U.S. Department
of Transportation
**Federal Highway
Administration**

In reply to: HSSD/WZ-277

In your letter of January 29 you requested the Federal Highway Administration (FHWA) acceptance of the modified and re-designed Multi Barrier Model MB 42 x 72 JSS longitudinal channelizing device as a crashworthy traffic control devices for use in work zones on the National Highway System (NHS). Accompanying your letter was the FHWA Office of Safety Design form, a drawing of the device, and a detailed description of previous testing you completed on a similar longitudinal channelizing device (WZ-255). The drawing and detailed description are enclosed with the acceptance form for the re-designed Multi Barrier Model MB 42 x 72 JSS longitudinal channelizing device. The re-designed device is intended for use with no more than 41 liters (10.8 gallons) of water in each module as ballast. You requested that we find this device acceptable for use on the NHS under the provisions of the National Cooperative Highway Research Program Report 350, "Recommended Procedures for the Safety Performance Evaluation of Highway Features".

WZ-277 Attachment #1: Description and discussion of modification to cra

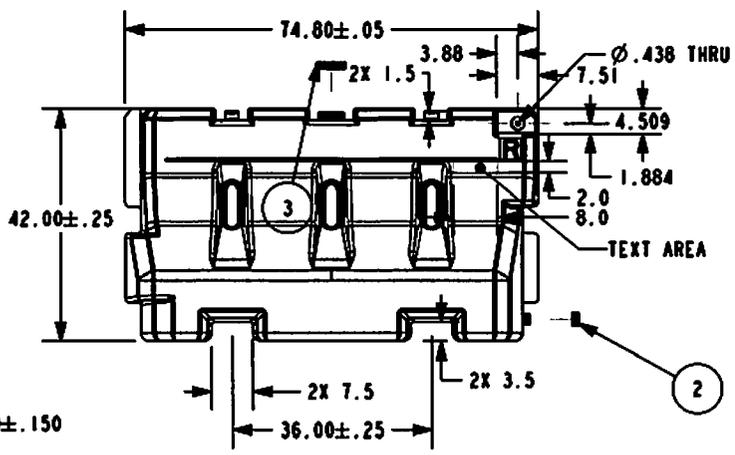
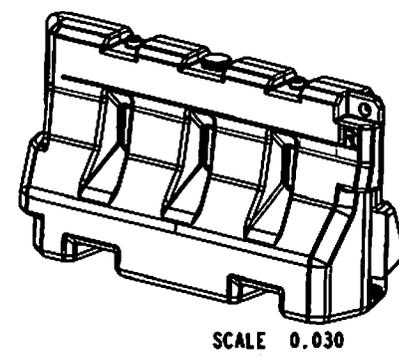
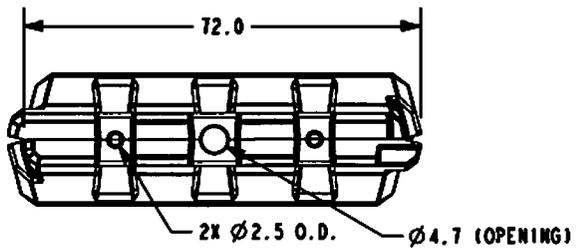
The tested LCB Model MB42x72 JSS LCB is 2 interconnected pieces, 42 high, 35 1/2 long, and 24 wide, for a total tested dimension of 42 high, 72 long, and 24 wide. The modified unit is one piece 72 long, 42 high, and 24 wide. We have eliminated the dog bone connection device in lieu of a one piece design. Essentially the weights and dims are the same. The water weight on the tested unit is poured into two chambers. The new unit is one single chamber with the same volume. The only difference is the connection.

We have eliminated the pin and doughnut connection as it will not come apart easily when lifted from the bottom in the back of a truck or in a work zone. The pin actually causes the water cell to rupture when lifted from the end. We have gone back to the same locating system we have used on the MB42x45 LCB (WZ-214). This system cannot actually lock together, either intentionally or unintentionally, so has the added benefit of gating without the possibility of locking when struck by a vehicle.

The dimensions are identical:

The material is also the same, HDPE with UV inhibitor and orange color additive.
